Application Reference: 17/2759/FUL

Site Address: Garages Adjacent 75 Churchview Road Twickenham

The application seeks planning permission for the demolition of an existing garage block and the erection of a mews development, consisting of 3 x 2 bedroom dwellings, together with associated car parking and landscaping works.

The Town and Country Planning Act 1990, (as amended)
Decision Notice

scheme: Churchview Road
Twickenham
client: UK & European Property
Developments Ltd
drawing: Tree Protection Plan
date: May 2017
scale: 1:200@A2
dwg no: PRI21193-03C
drawn: MW checked: RA

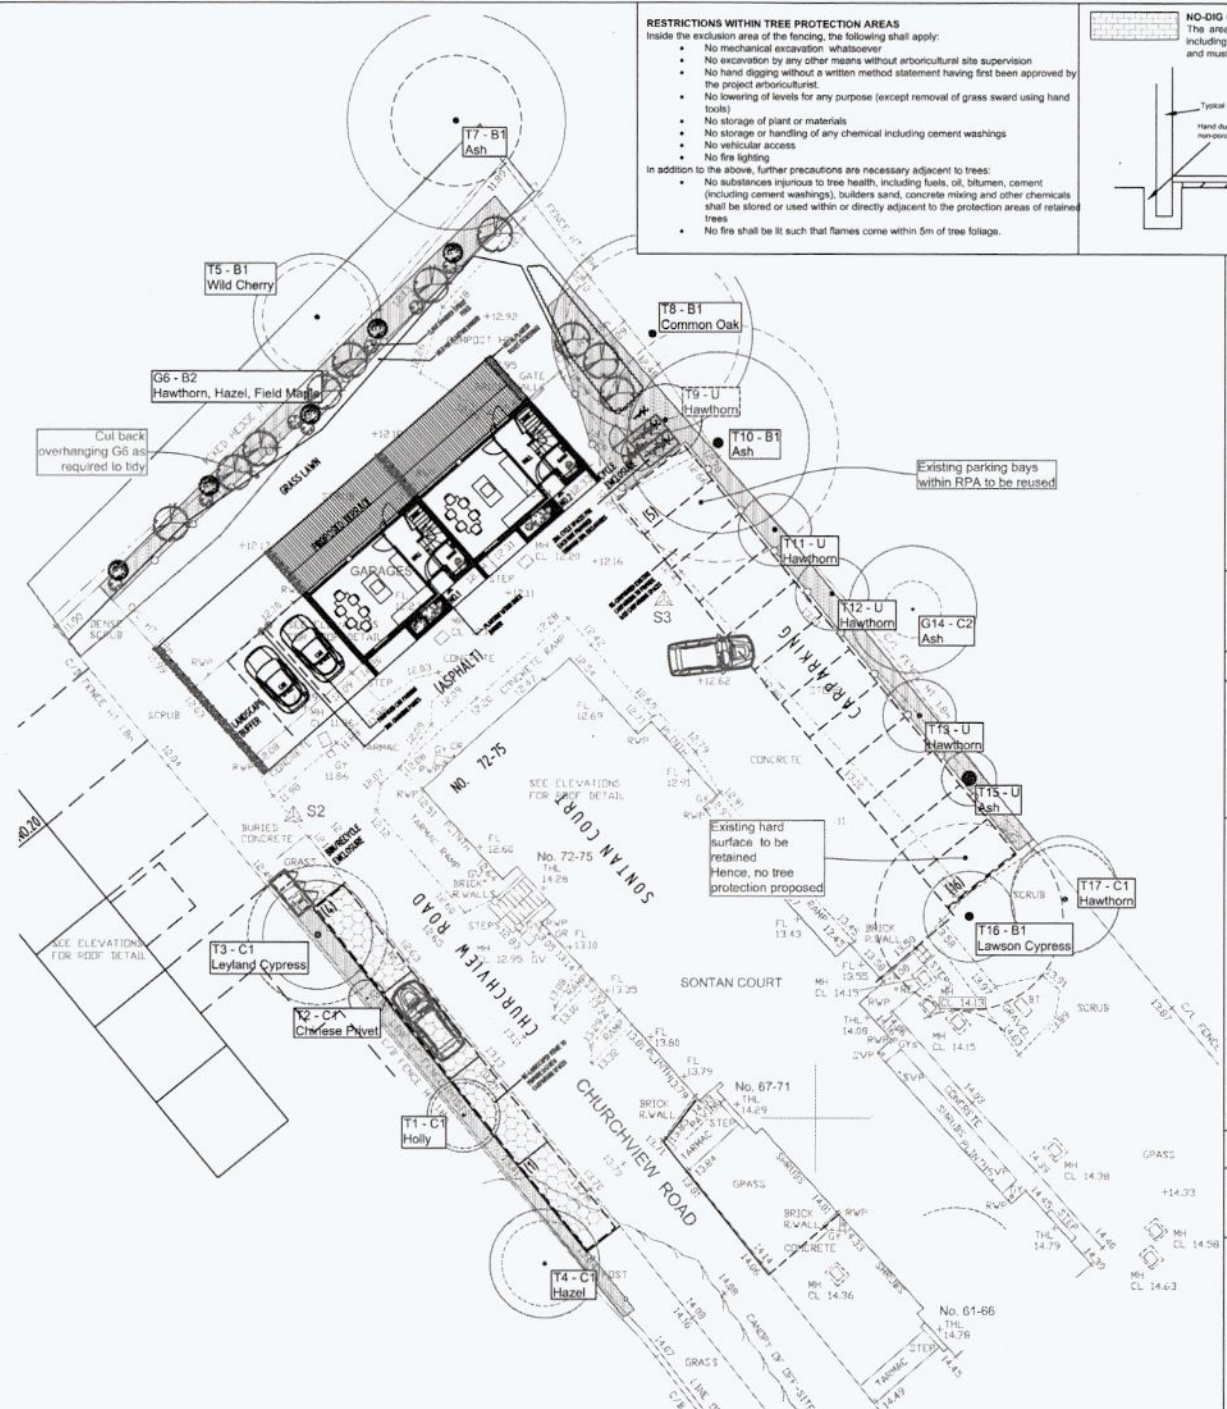
Rev	Date	Details	Drawn
C	13.01.2020	Layout revision/T11, 12, 13, 15 retained	TRG
B	19.06.2019	Layout revision	TRG
A	14.02.2019	Layout revision	MW
